SAN FRANCISCO PLANNING DEPARTMENT

Discretionary Review Abbreviated Analysis HEARING DATE: JANUARY 16, 2020

Date: December 30, 2019
Case No.: **2019-005400DRP-02**
Project Address: **166 Parker Avenue**
Permit Application: 2019.0410.7564
Zoning: RH-2 [Residential House, Two-Family]
40-X Height and Bulk District
Block/Lot: 1065 / 032
Project Sponsor: Jonathan Pearlman
Elevation Architects
1159 Green Street #4
San Francisco, CA 94109
Staff Contact: David Winslow – (415) 575-9159
David.Winslow@sfgov.org
Recommendation: **Do Not Take DR and Approve**

NORTH ELEVATION
Scale: 1/4" = 1'-0"

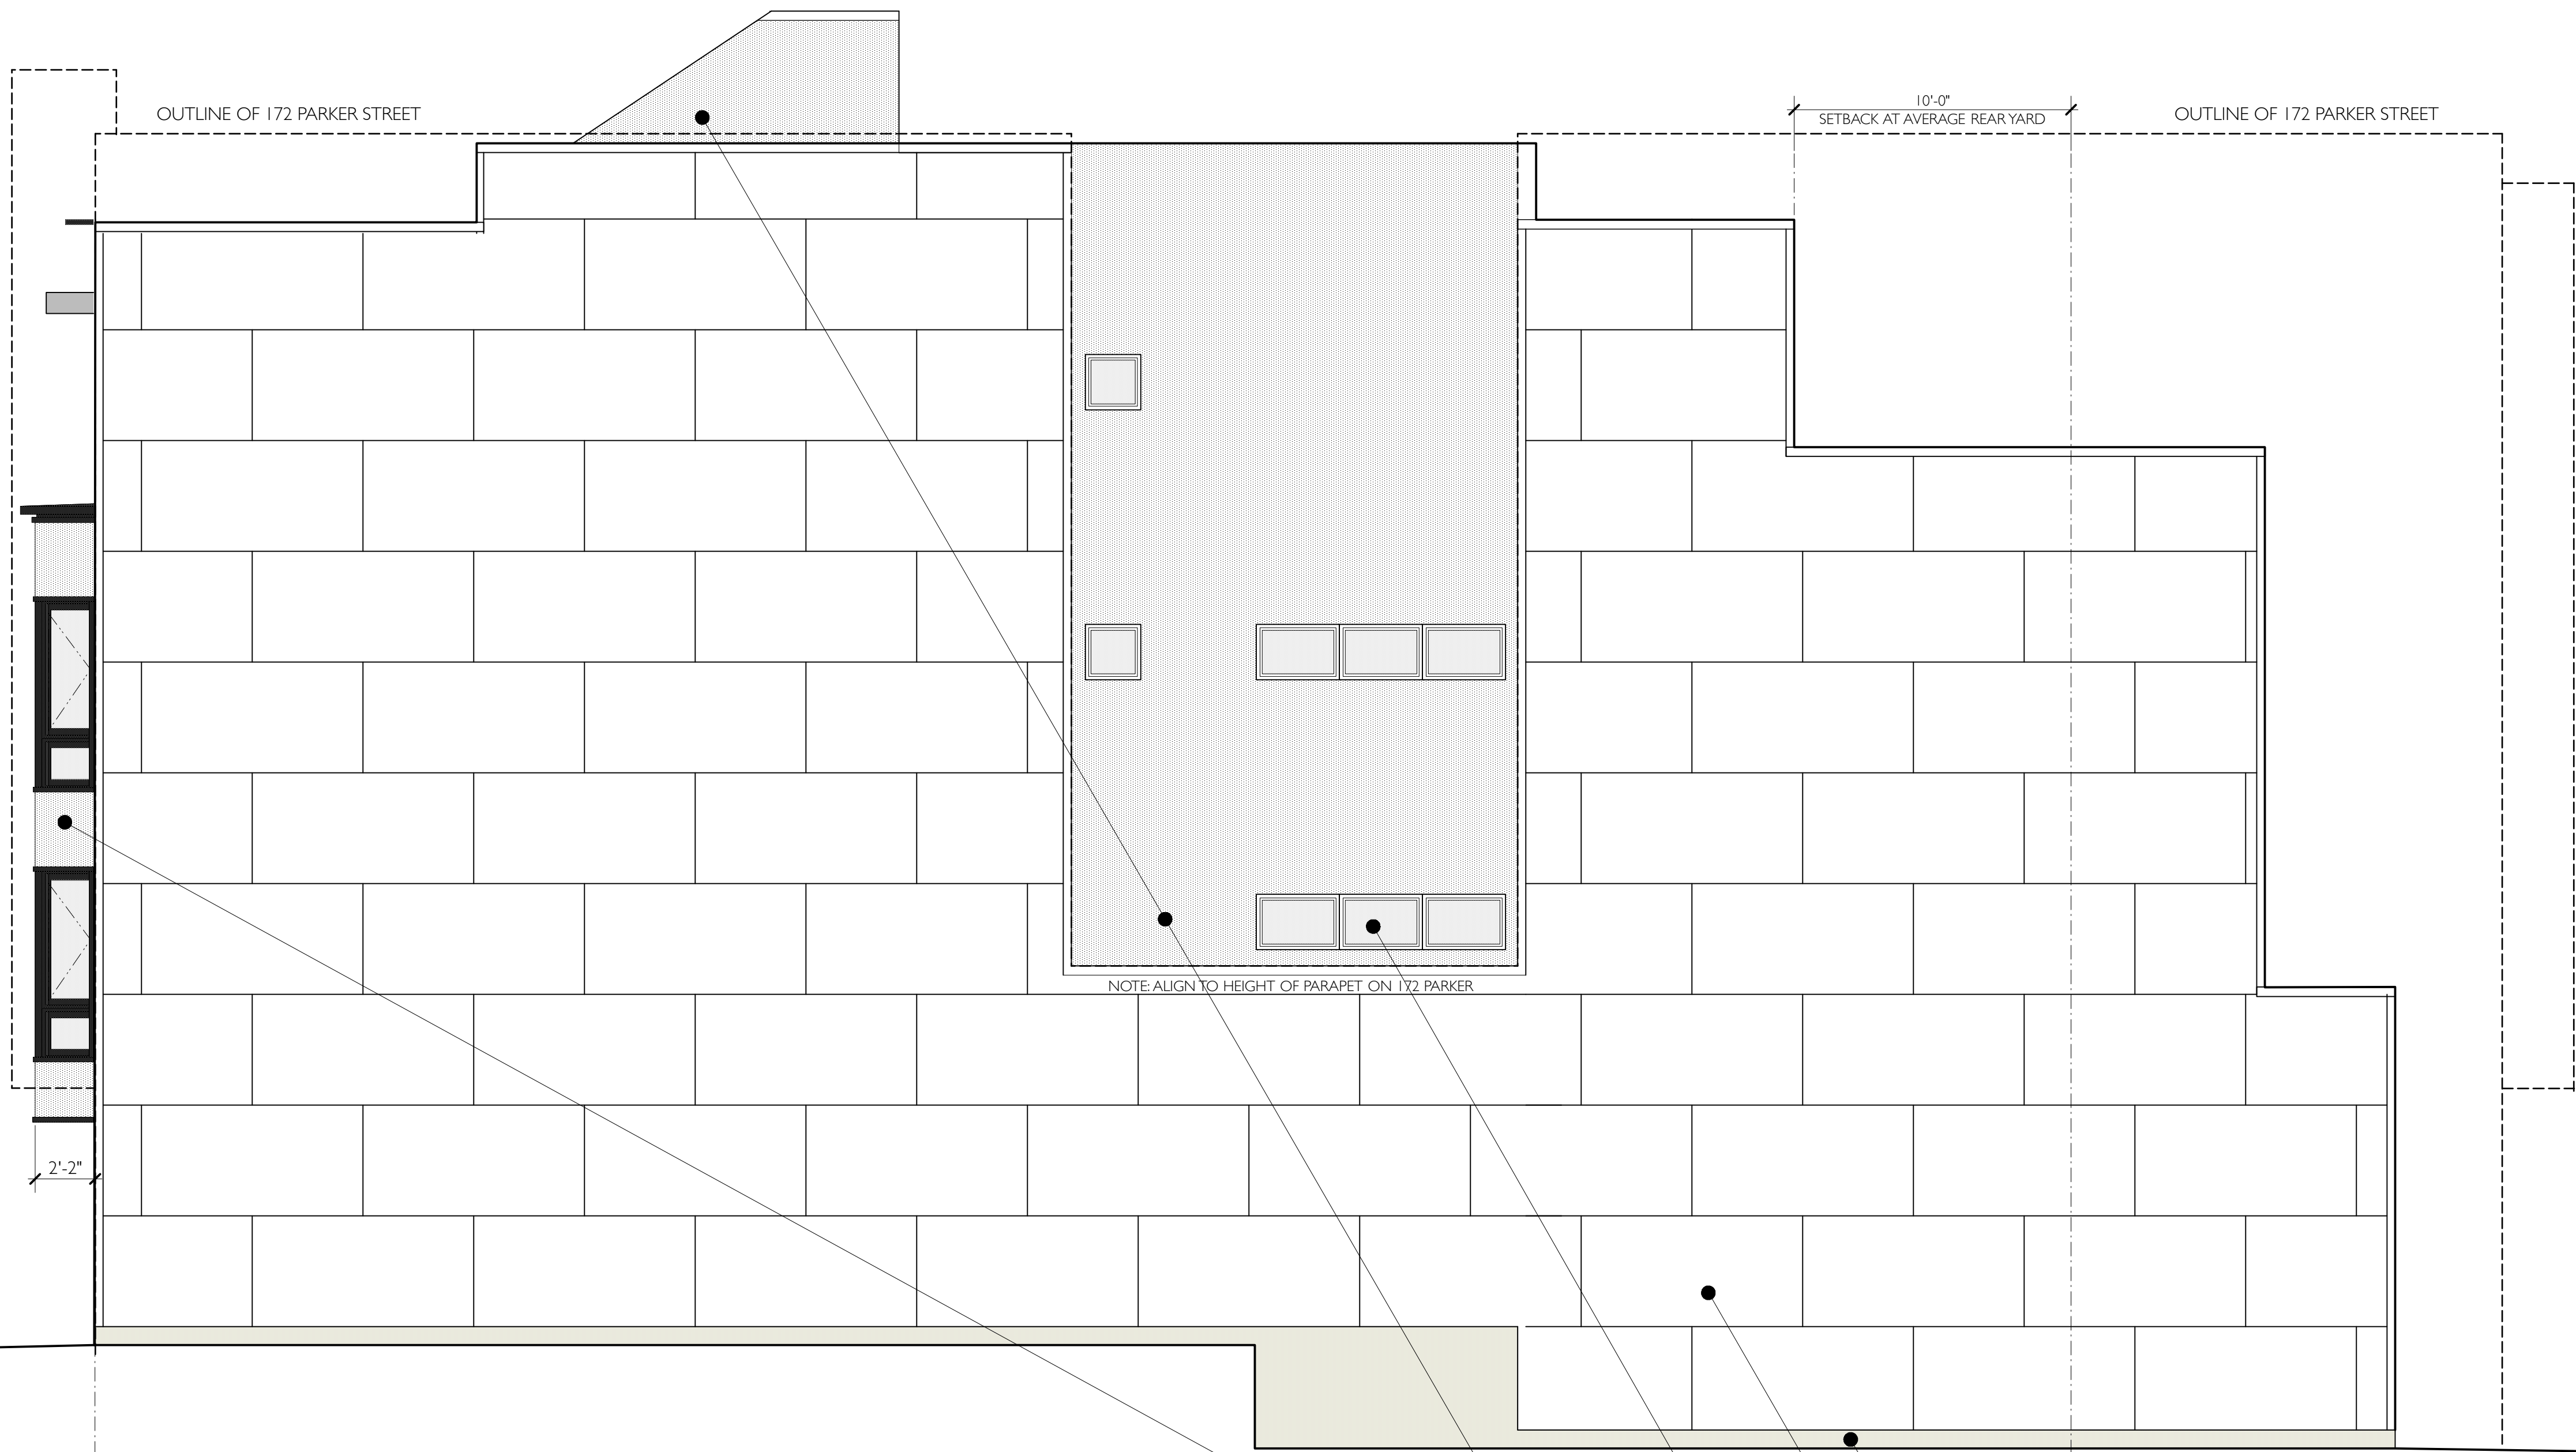
The current 166 Parker proposed plan of the rear at the north (adjacent to 164 Parker) extends 4'-9" beyond the depth of 164 Parker Ave. 164 Parker is proposing the 166 Parker north building wall be flush with the 164 Parker from Levels 2 to 4.

DR 1: The project as designed, sensitively addresses both the form and massing of the neighboring buildings at the rear yard or east end of the property. The reduction of the 4'-9" extension beyond 164 Parker would eliminate a bedroom in the lower unit of 166 Parker. The small portion that does extend beyond the setback that the DR requester is at issue with, is set 10'-8" south of the property line and is only 3 stories, not 4 for that portion of the building. Also, this portion of the building is set back 32'-6" from the rear property line, 16.5% more than is required. This rear yard massing is very modest as compared with similar buildings in the area or in any RH-2 zoning area. Therefore, the proposed building will not have any adverse effect on the surrounding properties and we are not willing to modify the project as requested in this DR application.
